S.R. 823 RAMP A (NB) OVER

OHIO RIVER ROAD (CR-503)

**STRUCTURE TYPE STUDY SUBMITTAL**

OCTOBER 31, 2006

**TYPICAL ABUTMENT SECTION**

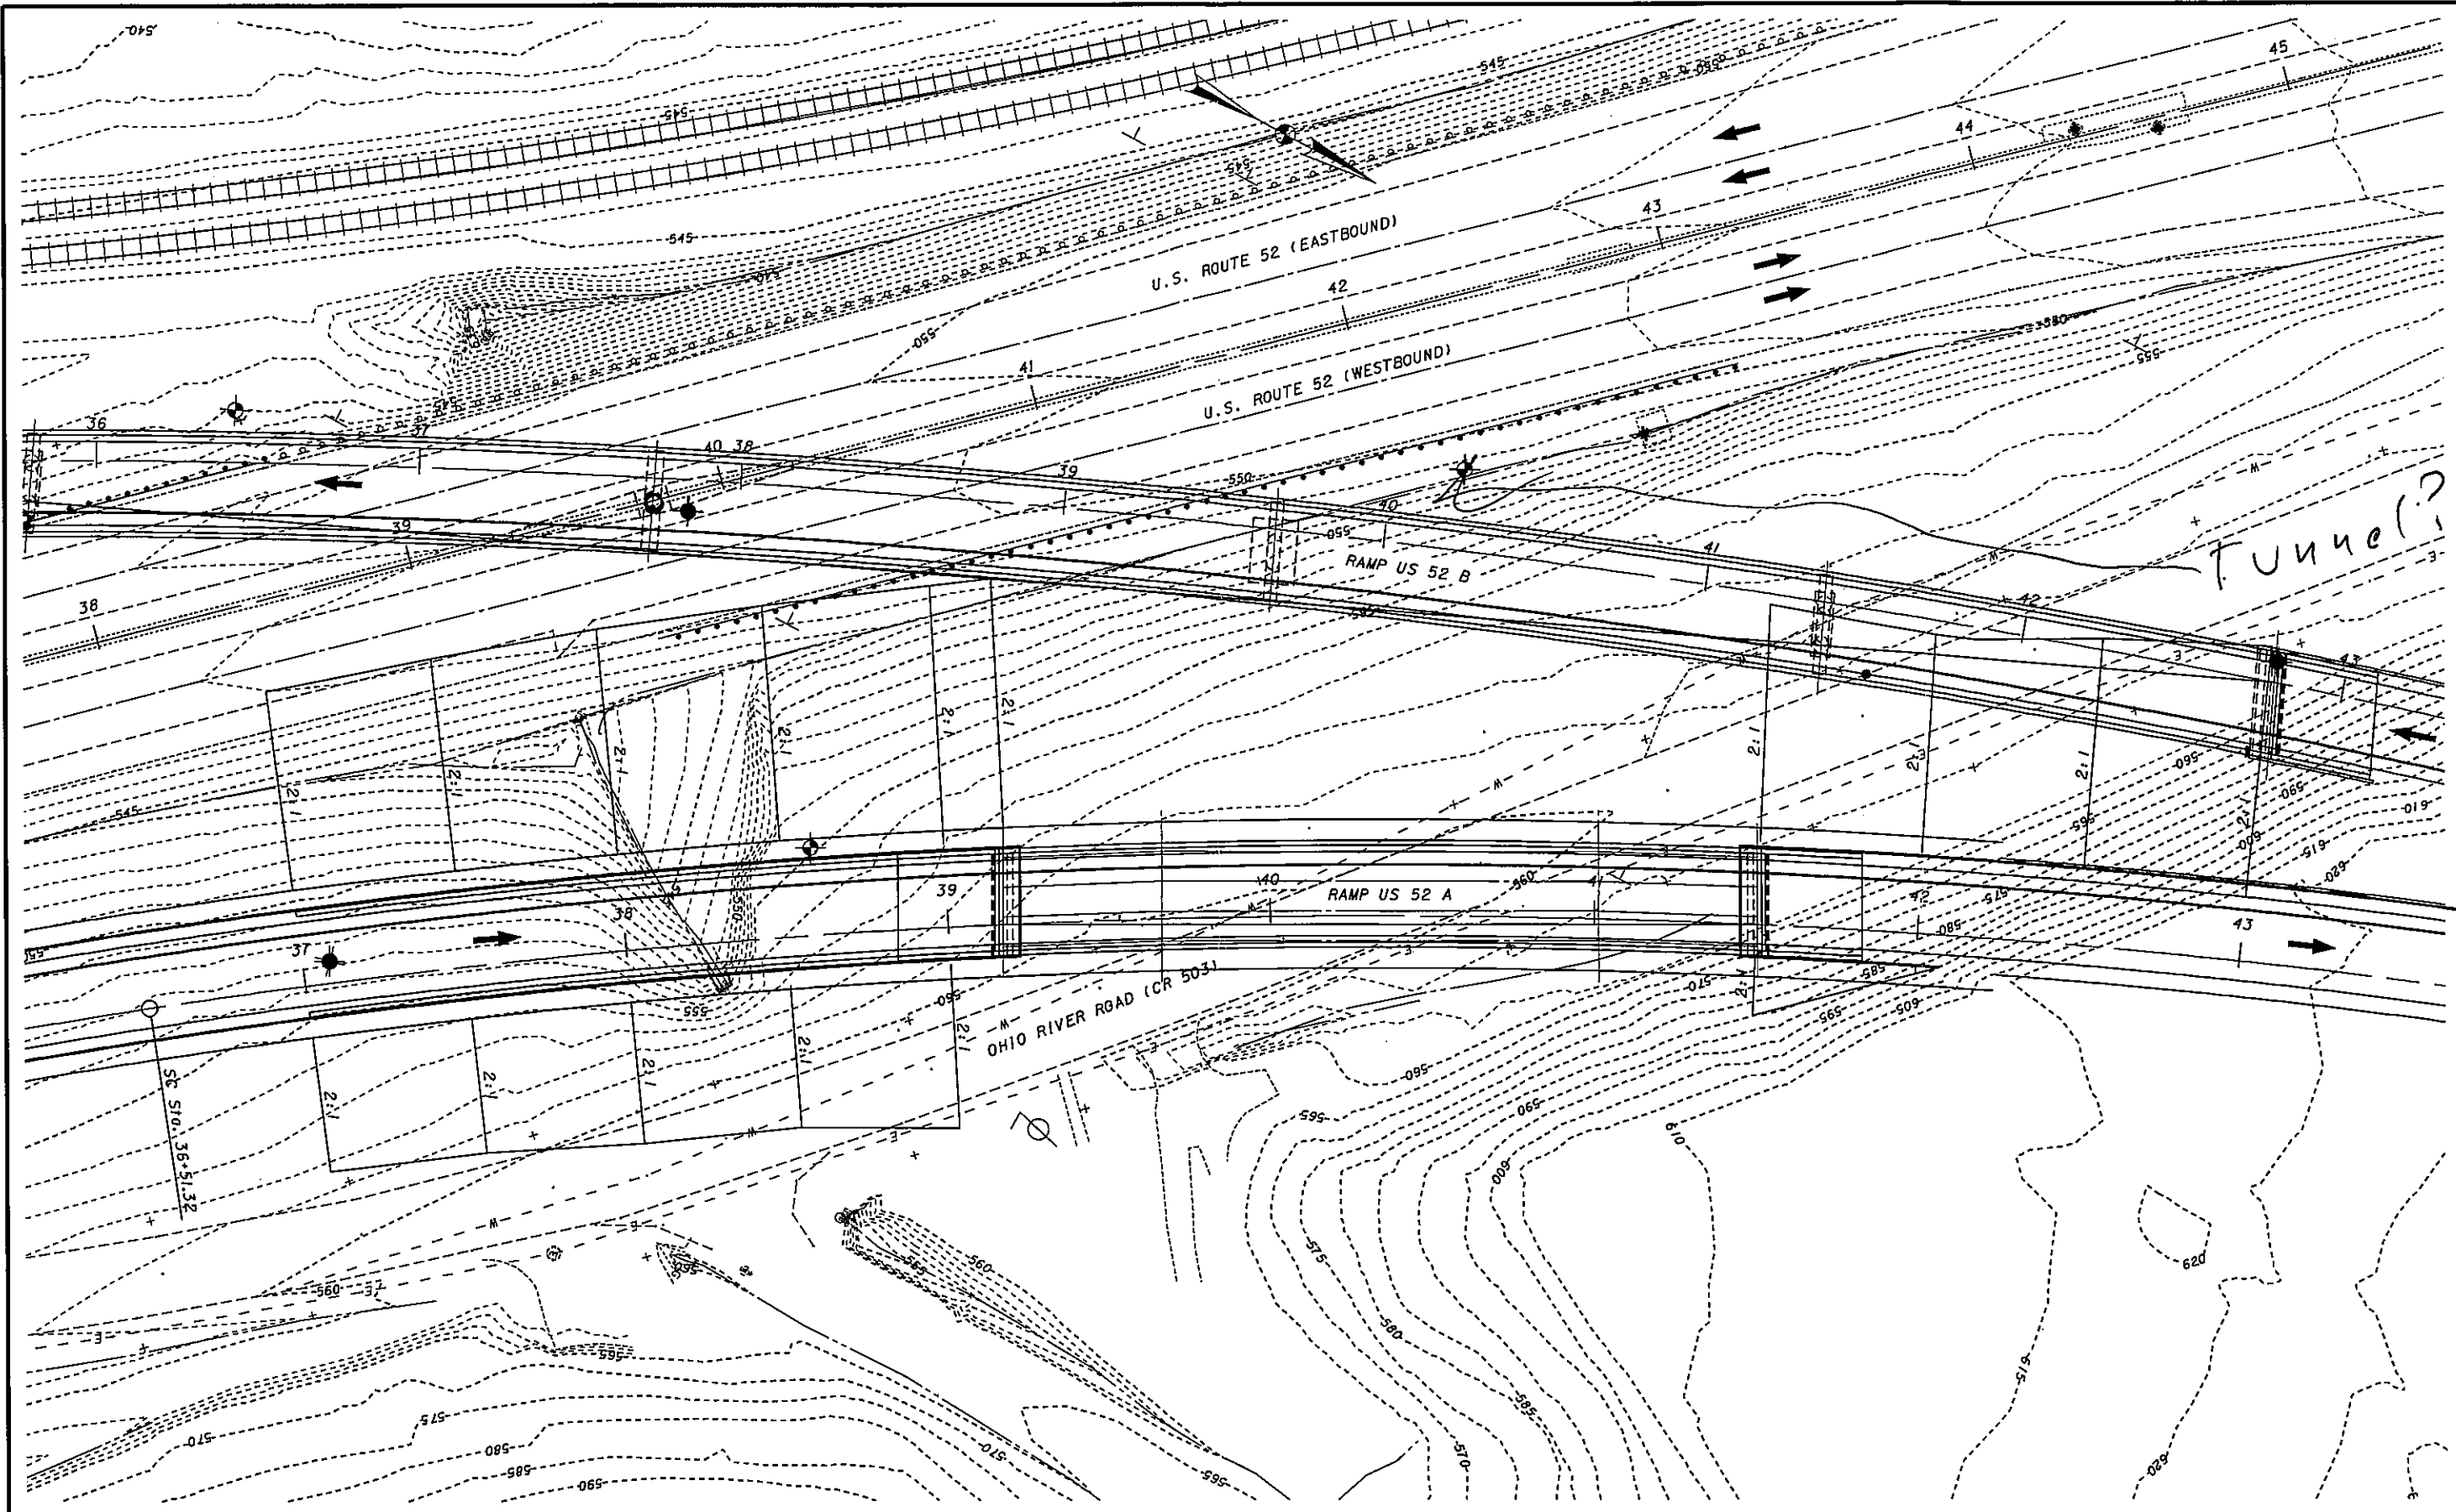
*show min. & max.*
